# Manual 19 – Periodic Review

Planning Committee  
October 3, 2023

- Periodic Review
  - Updated Approval section.
  - Section 3.2 updated to reflect change to hourly model and provide more clarity to price responsive demand forecast procedure.
  - Conforming revisions related to FERC Order ER20-217-000 in Attachment A.
  - Minor revisions to correct grammar, spelling, punctuation, consistency of terms and document references in Attachment D.

# Conforming revisions related to FERC Order ER20-217-000: PRD Revisions to align PRD rules with Capacity Performance construct

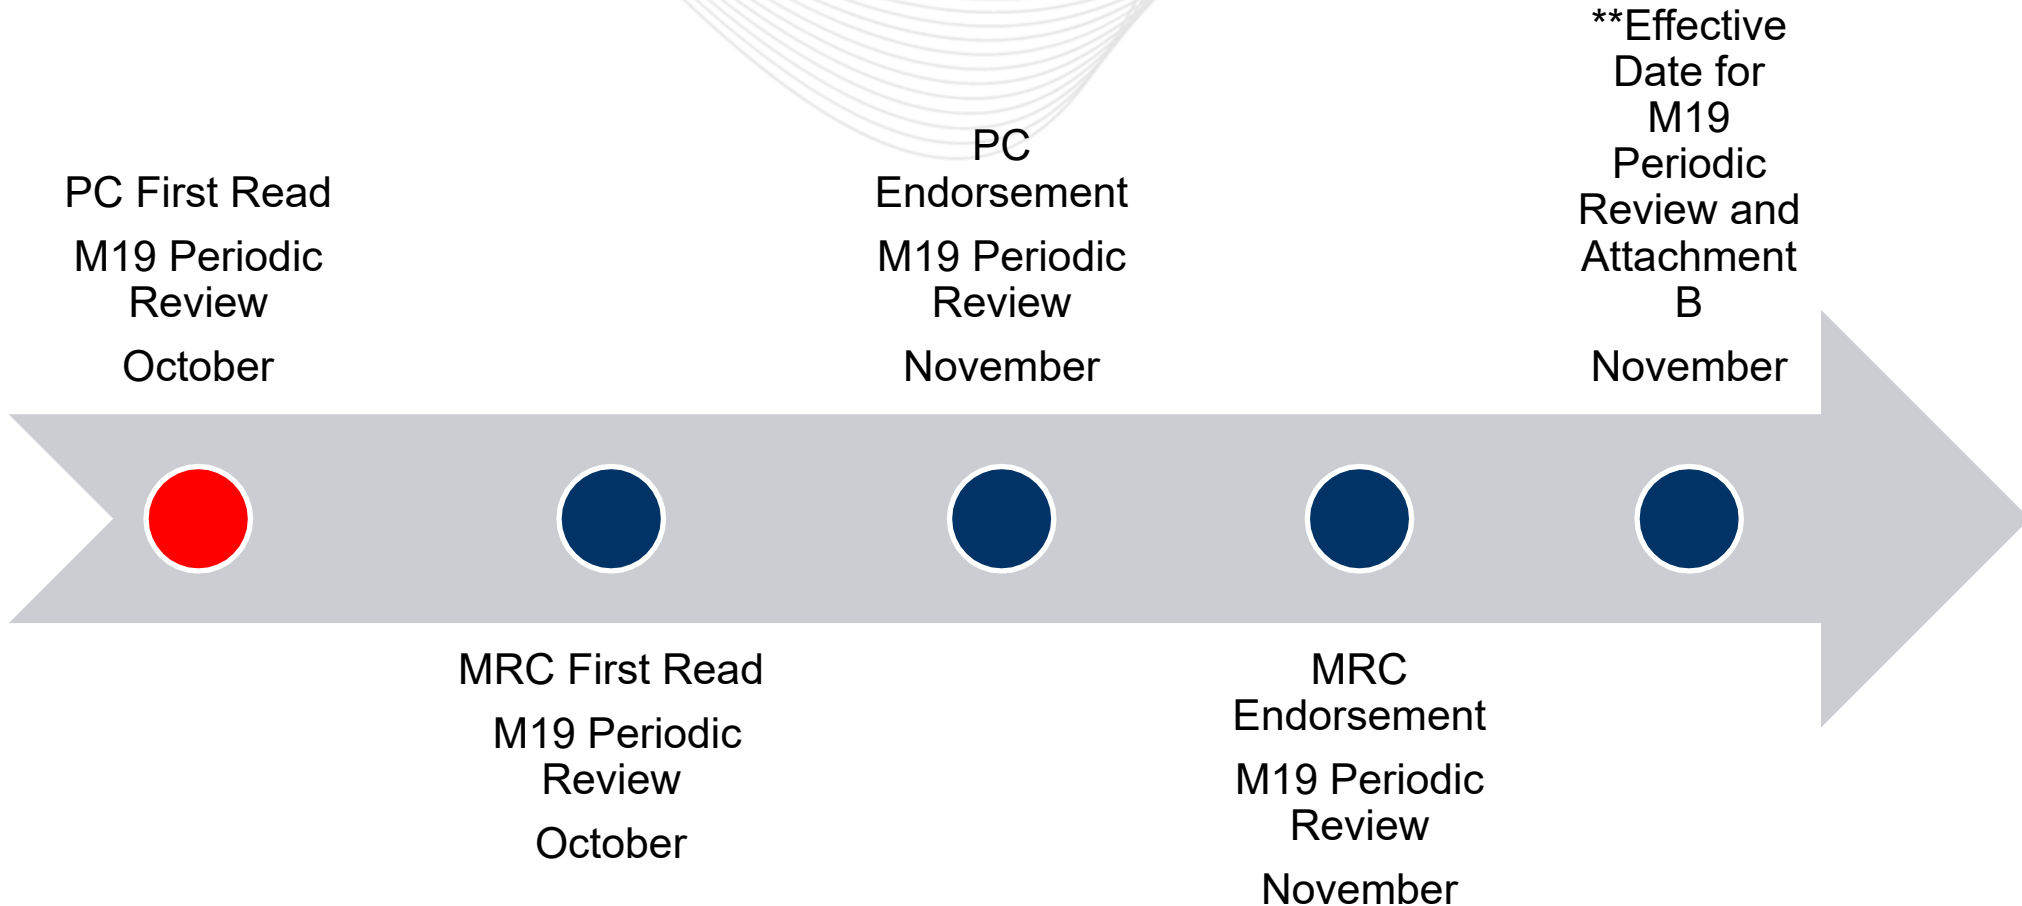
PJM is responsible for producing PRD load drop estimates, from PRD Provider input into the appropriate PJM system. ~~For purposes of 5CP identification, PRD Providers that registered price responsive demand to satisfy a PRD commitment for either RPM or FRR Alternative must provide PJM with meter data when PRD was required to be dispatched (LMP is greater than the offer price) for a set of high load days when PRD was required to be dispatched, to be identified by PJM by the end of each September. Meter data is entered at the site level; load drop estimates will be calculated at the registration level. ~~Load drop estimates will only be applied for Maximum Emergency Generation hours as well as for any 5CP hours when there was no Maximum Emergency Generation event.~~~~
